RE: MEDINA COUNTY
CITY OF WADSWORTH
RESTORED CHURCH OF GOD SUBDIVISION
NPDES PERMIT NO: OHC000003
OHIO EPA PERMIT NO: 3GC05928*AG
CONSTRUCTION STORM WATER INSPECTION

Storm Water Inspection

Table 2 - The diversion channel has been partially filled in due to soil stockpiling activities.

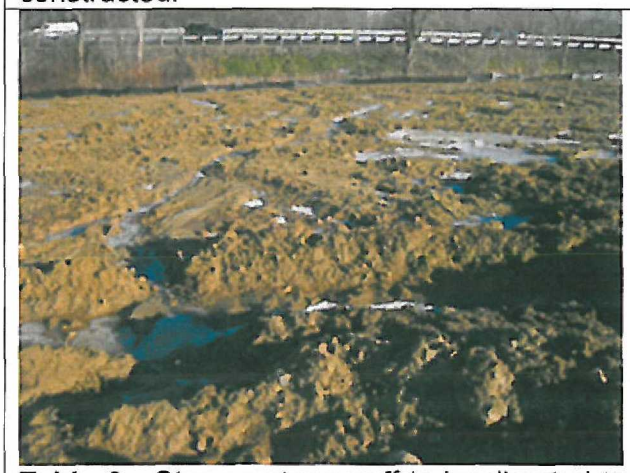
- A diversion channel is depicted on the SWP3 to direct storm water to the large sediment settling pond for treatment prior to discharge. The diversion channel has been partially filled in due to soil stockpiling activities (Figure 2), which has caused storm water runoff to be directed to the silt fence (Figure 3), located north of the site. The silt fence has failed due to concentrated flow events as sediment deposition was documented north of the silt fence. The diversion channel must be repaired to direct storm water runoff to the sediment settling pond for proper treatment.
